| 御中 | | | | | | | | | | | | | | Issue No. / 発行№: PC-0038163 | | | | | | | | | | | | | | |
| 工程変更連絡書 Process Change Notice | | | | | | | | | | | | | | ヒロセ電機株式会社 郡山工場 品質管理課 Koriyama Factory, Quality control section, Hirose Electric Co., Ltd. | | | | | | | | | | | | | | |
| 貴社品番/Product number of your company | | | | | | | | | | 弊社品番/Product number by Hirose Please refer to target product list | | | | | | | | | | 弊社品名/Product name by Hirose Please refer to target product list | | | | | | | | |

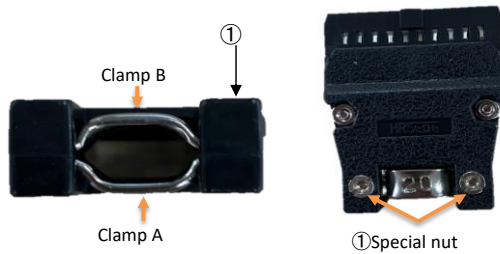
| Content of change / 変更内容 | 変更1 | 区分 Type | Material will be changed. | | | | | | | | | | 理由 Reason | To improve productivity | | | | | | | | | | | | | | |
| | 変更2 | 区分 Type | Dimension will be changed. | | | | | | | | | | 理由 Reason | Since the thickness of material changes due to the change of material. | | | | | | | | | | | | | | |
| | Clamp A・B Material: SWRM6 Thickness: 1.45mm Special nut: 4.29mm | | | | | Clamp A・B Material: SPCC Thickness: 1.57mm Special nut: 4.04mm | | | | | Appearance will change due to the change of material. We will conduct the necessary evaluations. | | | | | | | | | | | | | | | | | |
